**Document**
20240027-AR-DA002

**Project**
16-20 Old Castle Hill Road, Castle Hill

# SDRP HDA Response Report

## 16-20 Old Castle Hill Road
## Castle Hill

# 2.1 Context & Precinct Response
## Castle Hill Context

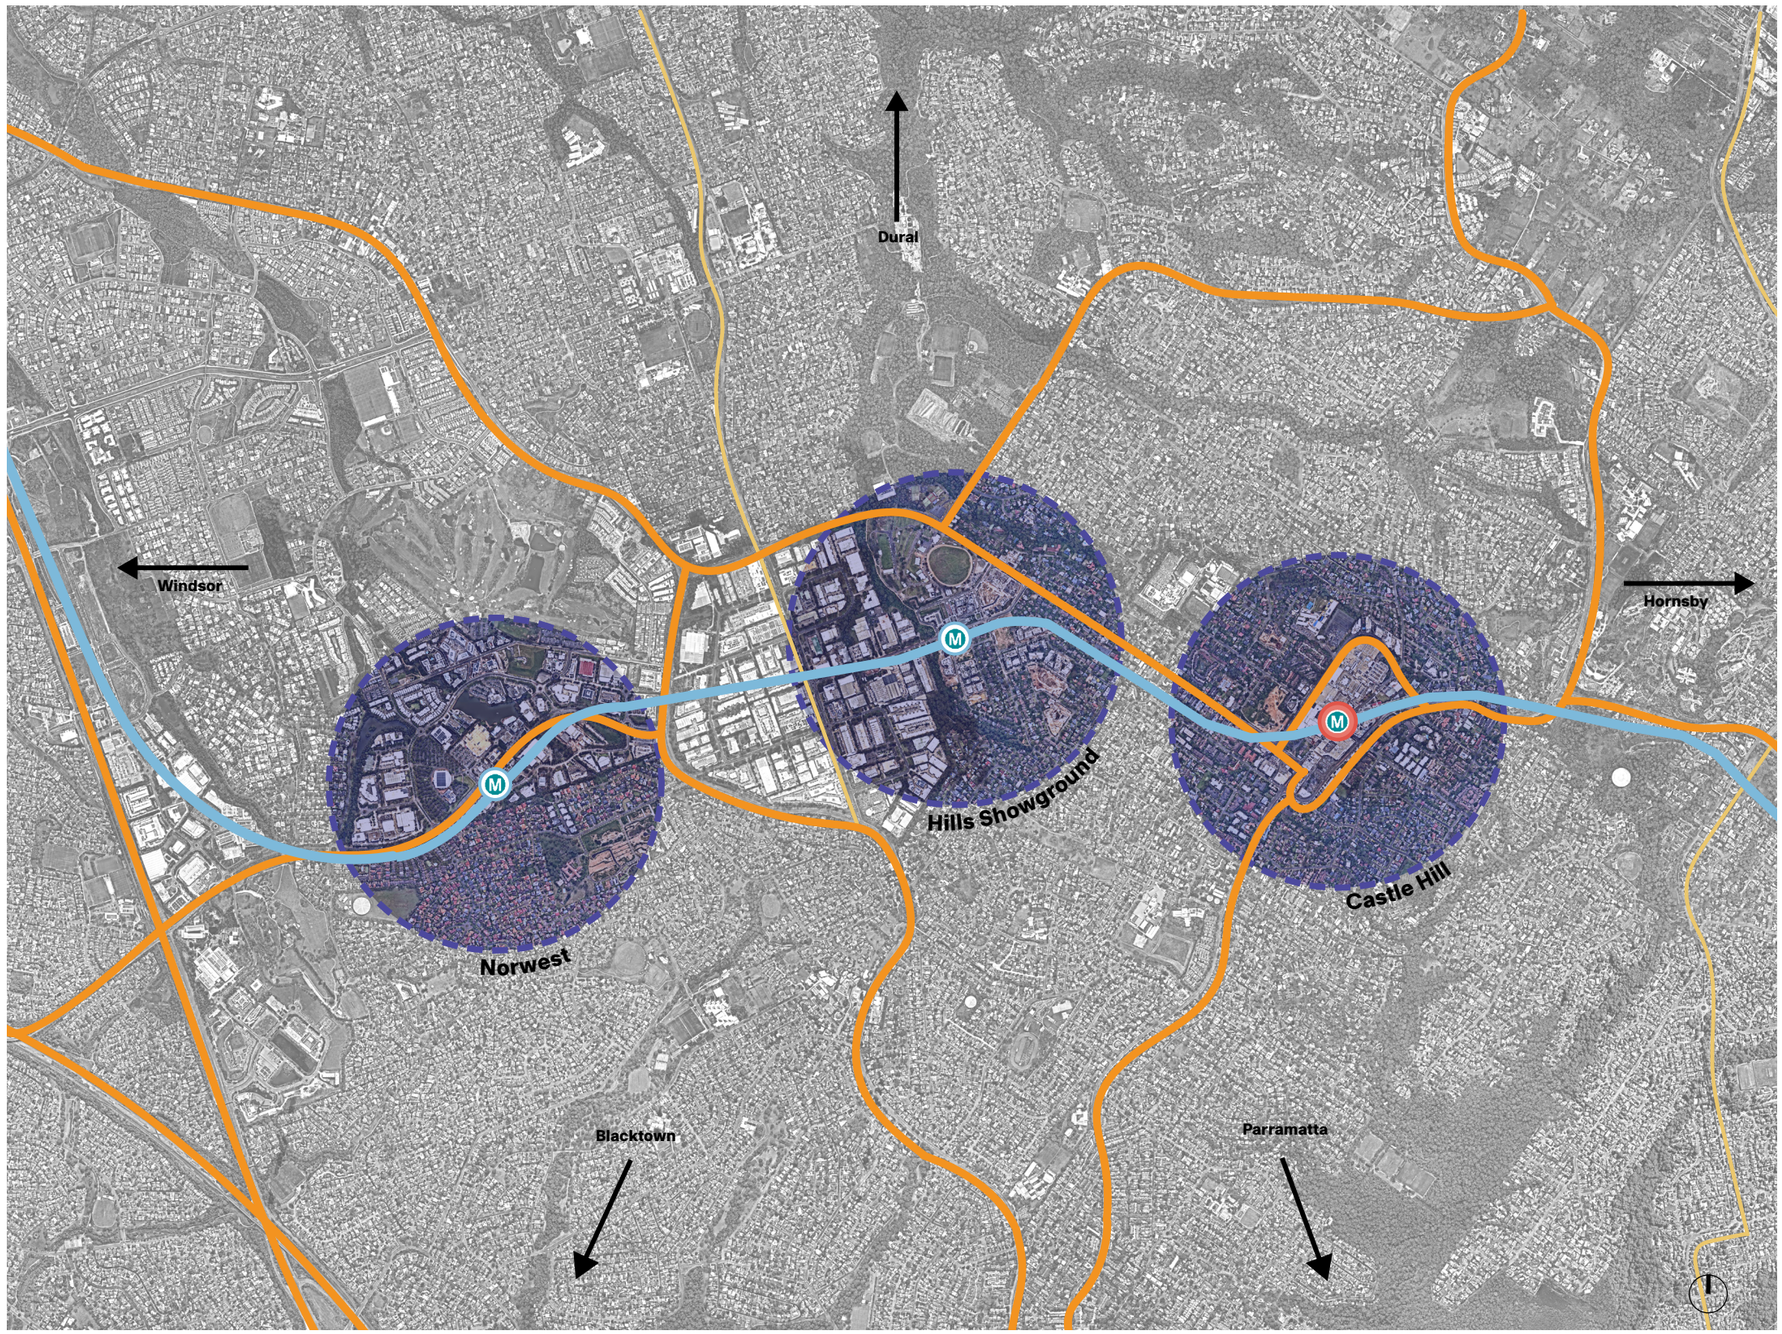
- **Item 04.** Provide a comprehensive contextual analysis to justify the proposed increase in height and scale, and ensure future surrounding sites are considered.
- **Item 04a.** Demonstrate how contextual analysis has informed the design outcomes and reinforces the site's role as a proposed strategic gateway within the Castle Hill Centre.
- **Item 04b.** Illustrate how the building and architectural language contribute to a coherent skyline condition rather than presenting as an isolated tall form.
- **Item 04c.** Provide visual analysis through short, medium and long-distance views of the proposal within the town centre, considering both current and future conditions.

The analysis considers Castle Hill's role within the broader strategic centre network, drawing comparisons with neighbouring Metro-served precincts including Hills Showground and Norwest. It highlights the significance of the **Metro corridor** and the network of **primary vehicular and freight routes** connecting Parramatta, Blacktown and Dural, which support movement, accessibility and economic activity across the region. Positioned along these major transport corridors, each precinct functions as a **key node within the metropolitan network**, facilitating connections between residential, employment and commercial destinations. The site's location within this framework reinforces its strategic importance as part of a broader network of transit-oriented centres and **nodular gateway locations**.

## Precinct Context - Viewlines

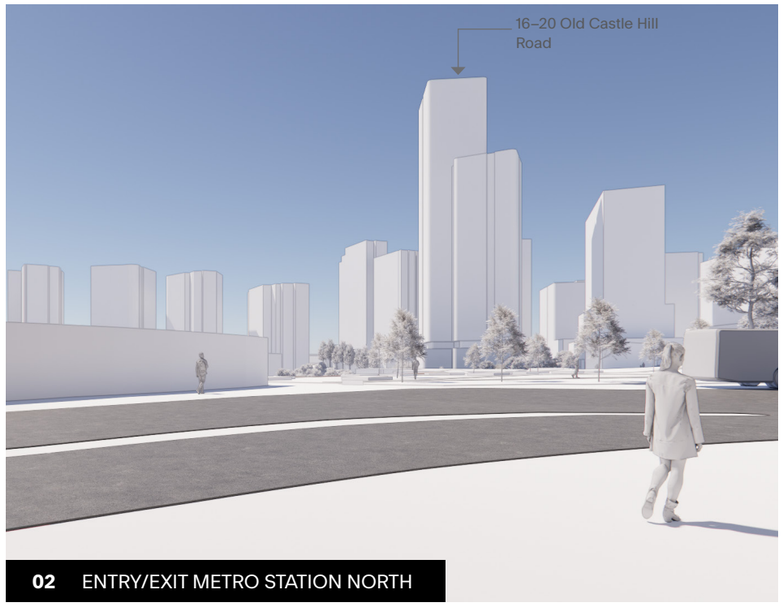
| SDRP 03 Feedback | | | |
|---|---|---|---|
| **4c.** | Provide visual analysis through short, medium and long-distance views of the proposal within the town centre, considering both current and future conditions. | A comprehensive visual impact assessment has been undertaken through a series of short, medium and long-distance view analyses from key locations within the Castle Hill Centre. The **assessment tests the proposal against both existing and future** planned built form scenarios, demonstrating how the development integrates within the evolving town centre skyline. By considering future context planning alongside the proposal, the analysis confirms that the height and scale contribute to a **coherent and legible urban form**, reinforcing the strategic centre character and gateway role of the precinct rather than presenting as an isolated tower outcome. | ▪ Pages 18 |

A comprehensive visual impact assessment has been undertaken through a series of short, medium and long-distance view analyses from key locations within the Castle Hill Centre. The **assessment tests the proposal against both existing and future** planned built form scenarios, demonstrating how the development integrates within the evolving town centre skyline. By considering future context planning alongside the proposal, the analysis confirms that the height and scale contribute to a **coherent and legible urban form**, reinforcing the strategic centre character and gateway role of the precinct rather than presenting as an isolated tower outcome.

SDRP HDA RESPONSE - BASEMENT

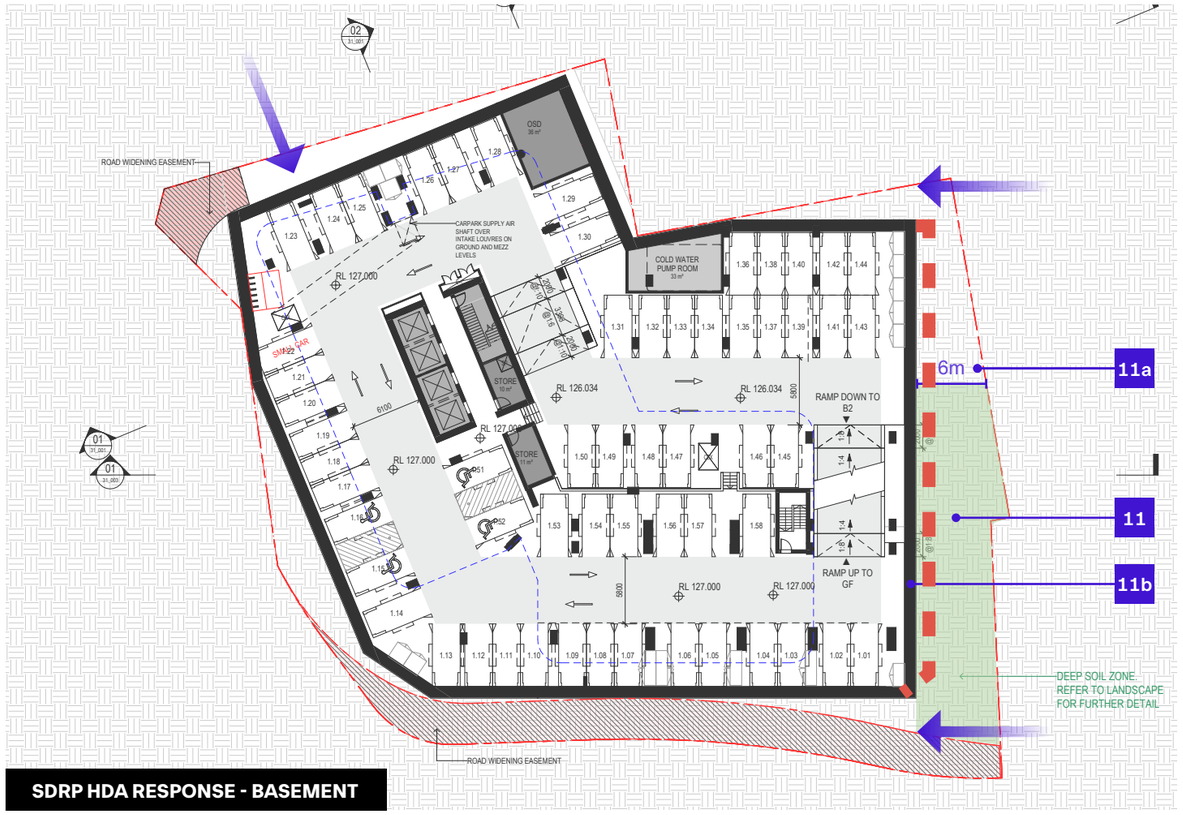
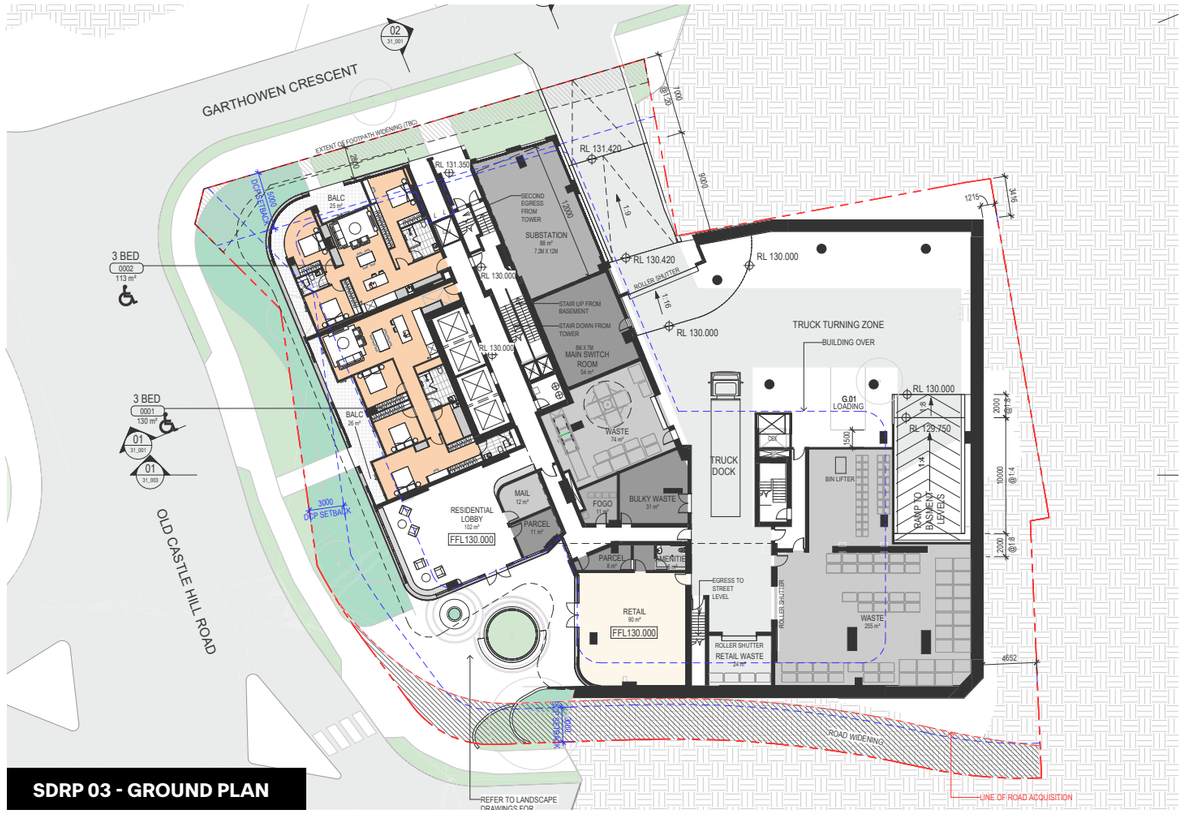
- **Item 11.** Increase deep soil provision to improve landscape and ecological outcomes.
- **Item 11a.** Demonstrate that deep soil areas comply with ADG minimum requirements, including recommended widths, and are not reliant on adjoining sites to achieve continuity.
- **Item 11b.** Explore reducing car parking provision to enable a smaller basement footprint, noting the site's proximity to Castle Hill Metro Station.

Deep soil provision has been increased to 212m², equating to 7% of the site area. This represents a significant improvement from the previous scheme, which achieved no compliant deep soil planting areas once the road widening easement was excluded, despite identifying 475m² of landscape area.

The basement footprint has been reduced to allow for proper deep soil in accordance with the ADG (min. 6m in width).

Deep soil provision has been designed to comply with ADG requirements (min. 6m in width) and even exceeds this requirement in key landscaping zones.

The basement has naturally decreased in footprint due to the extended deep soil zones (refer to 11, 11a). Car parking provision has since been reduced from 386 to 353 (33 less).

SDRP HDA RESPONSE - GROUND PLAN

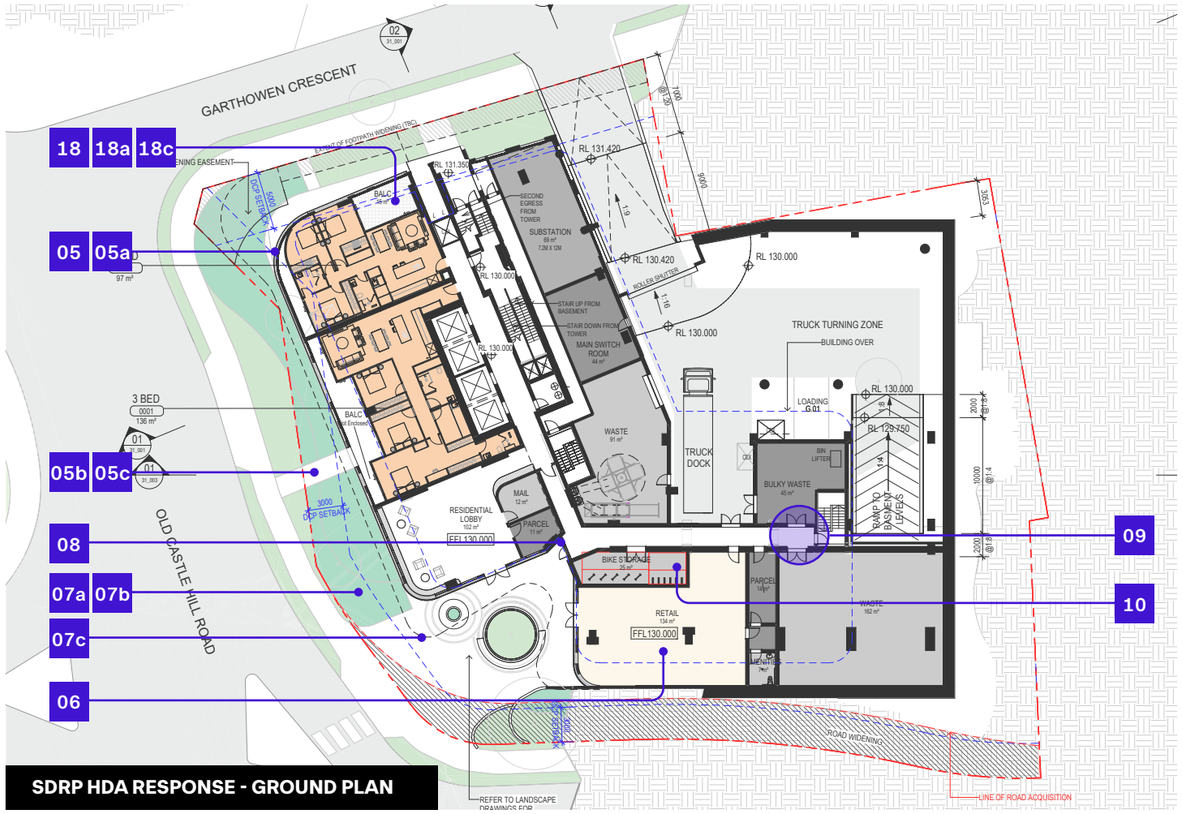
- **Item 05.** Resolve the ground level apartment interfaces, particularly along McMullen Avenue, ensuring residential amenity and streetscape quality considers street conditions before and after road widening.

- **Item 05a.** Demonstrate that the podium setback maintains sufficient separation and delivers clear, high-quality amenity for both terrace residents and pedestrians.

- **Item 05b.** Demonstrate how privacy and security is provided to ground level apartments at the varying edge conditions.
- **Item 05c.** Ensure ongoing accessible street access to ground level apartments.

- **Item 06.** Ensure the ground floor entry and retail forecourt deliver a high level of residential and public amenity, addressing noise, solar access, pedestrian movement and overall spatial quality, creating a welcoming and activated space.

- **Item 07a.** Improving the clarity and legibility between public and private zones
- **Item 07b.** Ensuring safe, continuous and well-defined pedestrian movement through the site edges.

- **Item 07c.** Ensuring appropriate wind mitigation measures are incorporated to provide comfortable sitting and walking environments.
- **Item 08.** Review resident entry circulation to lobbies, lifts, and ground floor apartments to simplify circulation, improve sightlines and provide ample daylight access.

- **Item 9.** Demonstrate that servicing, loading and waste collection can be accommodated safely and efficiently without compromising pedestrian amenity, landscape outcomes or residential interfaces.

- **Item 10.** Provide bike parking at ground level that is accessible and caters to families.
- **Item 18.** Ensure lower-level apartments deliver high quality residential amenity, given their proximity to high-traffic streets.

- **Item 18a.** Demonstrate how noise impacts have been mitigated and informed apartment layouts.
- **Item 18c.** Ensure balconies and private open spaces are comfortable, useable and appropriately protected from noise.

**Item 05, 05a-c Response**
The amenity and street interface between the ground floor apartments and immediate streets have greatly improved through a series of buffered interventions that allow for a comfortable transition from public to private.

Direct access is still maintained with a layered landscape and built approach to providing security and private spaces which respond to existing and future road widening conditions.

**Item 06 Response**
The retail offering has been increased to 133m² formally anchoring itself along the McMullen Avenue frontage to its mirrored Resident Entry.

The forecourt remains a central mainstay as a sheltered public living room that is buffered along the primary intersection.

**Item 07a-b Response**
Clarity is improved through a series of architectural and landscaped zones which negotiate the building's primary pedestrian entry between the two volumes and steep terrain.

**Item 07c Response**
Awnings have been appropriately placed where necessary to improve pedestrian comfort.

**Item 08 Response**
Resident entry circulation has been reviewed and refined to improve clarity, legibility and amenity between lobbies, lifts and ground floor apartments.

An additional residential entry point has also been introduced to provide direct and secure access to bulky waste and bicycle storage facilities, improving convenience and operational efficiency for residents while maintaining separation from public and service interfaces.

**Item 18, 18a, 18c Response**
Ground floor apartments have been refined to ensure high-quality residential amenity in response to primary arterial roads.

Furthermore, layouts have been refined to negotiate noise exposure considering acoustic recommendations, through appropriate screening and spatial separation. This extends to ensure a comfortable and usable balcony.

**Item 09 Response**
Servicing and waste facilities have been rationalised into distinct areas away from residents improving safety and operation.

**Item 10 Response**
Ground level bike parking provided with direct, step-free access from the street, ensuring clear accessibility for all users, including families.

**SDRP HDA RESPONSE - TYPICAL MID PLATE**

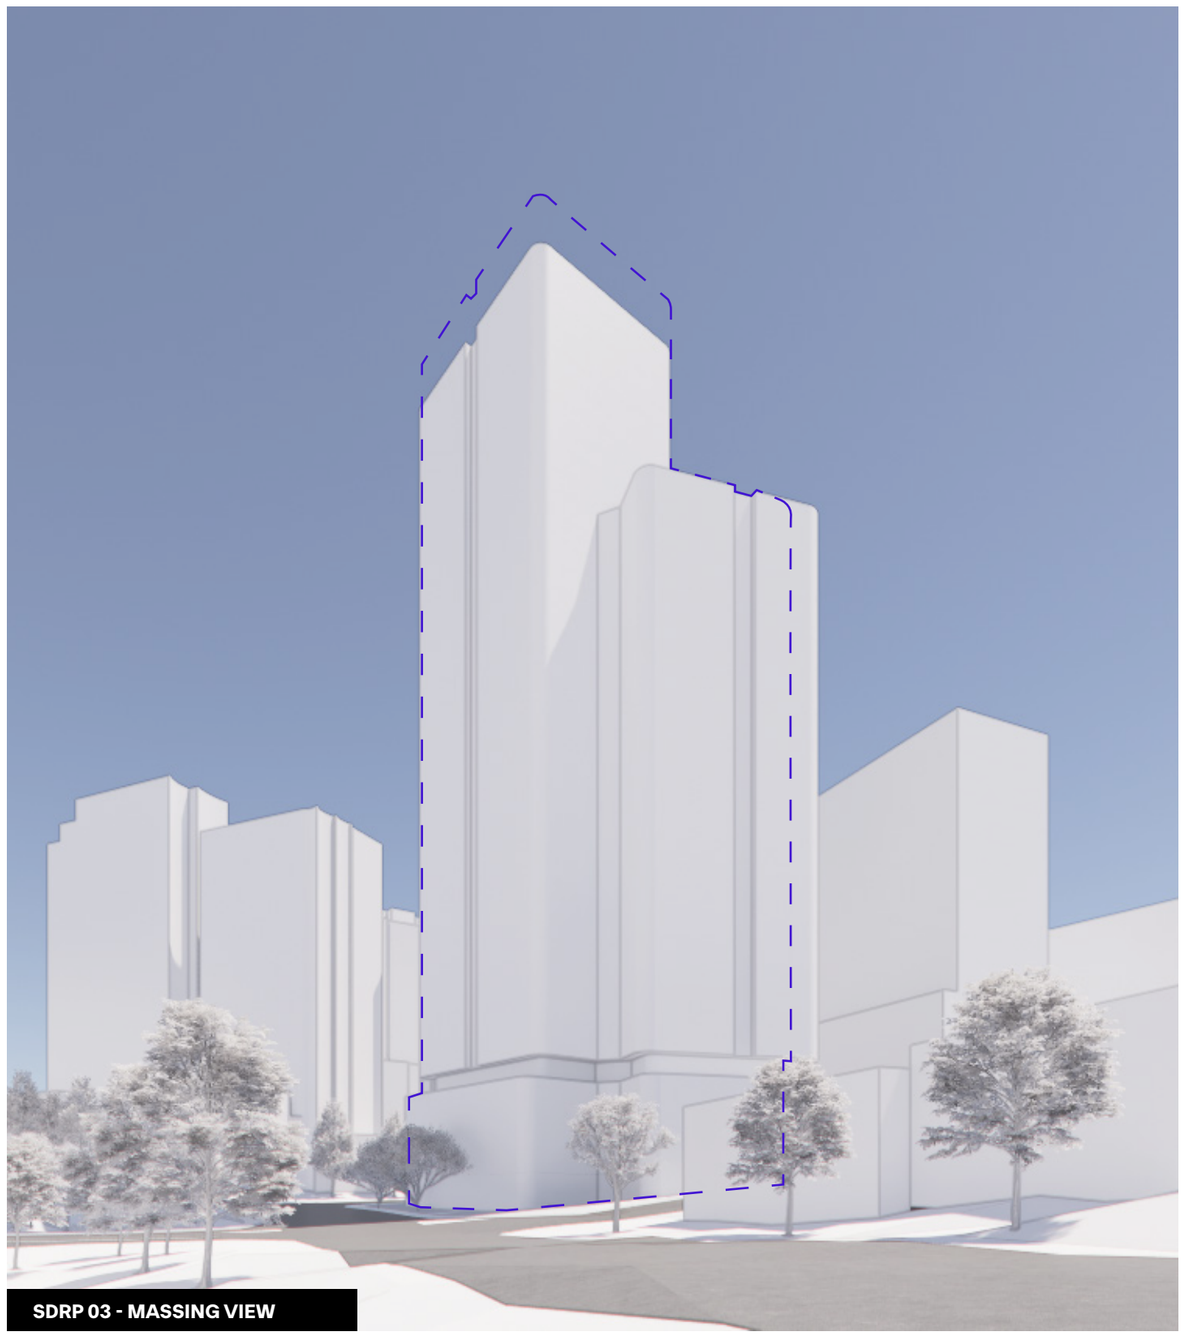
- **Item 18b.** Ensure all habitable rooms achieve natural ventilation while addressing noise impacts.
- **Item 19.** Improve the amenity of podium and tower circulation corridors through:
  a. Reducing their length
  b. Increasing access to daylight
  c. Ensuring natural ventilation is accessed throughout
- **Item 20.** Review internal planning of apartments, including knuckle units and deep-plan conditions, to ensure functional efficiency and high amenity.
- **Item 21.** Clearly demonstrate compliance with ADG solar and cross-ventilation requirements, noting units currently identified as compliant do not appear to achieve this. Include solar access to living rooms and private open spaces, and cross-ventilation diagrams.

**Item 18b Response**
Natural ventilation has been provided to all habitable rooms through operable windows which also ensure appropriate access to daylight.

Walk-up apartments have been reconfigured into single storey apartments ensuring compliant ventilation access across all dwellings.

**Item 19a Response**
Corridor lengths have been improved to ensure managable access to apartments on the entire floorplate.

Corridor terminations have been improved on the South-East to provide light to corridor, improving comfort and engagement to the outside.

**Item 19b Response**
Corridor amenity improved through increased access to natural daylight through operable windows at both ends of podium and tower circulation corridors.

**Item 19c Response**
Natural ventilation achieved throughout circulation corridors via operable windows at both ends, enabling continuous airflow and improved thermal comfort.

**Item 20 Response**
Internal apartment planning has been refined following a further tower setback, improving building efficiency and concerns around deeper apartments with 2 Bed from a 3 Bed.

**Item 21 Response**
The revised scheme achieves 71% Solar and 60% Cross Vent across all apartments.

Living rooms have been refined to improve daylight and spatial amenity whilst providing quality private open space.

## Overshadowing - Communal Open Space

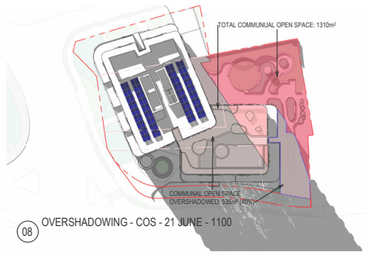
- **Item 15a.** Provide detailed analysis of overshadowing impacts on communal open spaces, particularly at ground level, considering future neighbouring developments.

A detailed solar access assessment has been undertaken for all communal open space areas, analysing shadow impacts from 9am to 3pm. The assessment demonstrates compliance with ADG requirements, with **more than 50% of the communal open space receiving a minimum of two hours of direct sunlight** between 9am and 11am. While the overall communal open space area has reduced from 1,310m² in the previous SDRP scheme to 1,228m² in the current proposal, solar access outcomes remain proportionate to the available communal area and continue to provide equitable access to sunlight for residents. Comparative analysis also indicates that overshadowing during the most affected afternoon period (12pm–3pm), including at 2pm, has been reduced relative to the previous scheme, resulting in improved ground-level communal open space amenity and usability despite the revised built form.
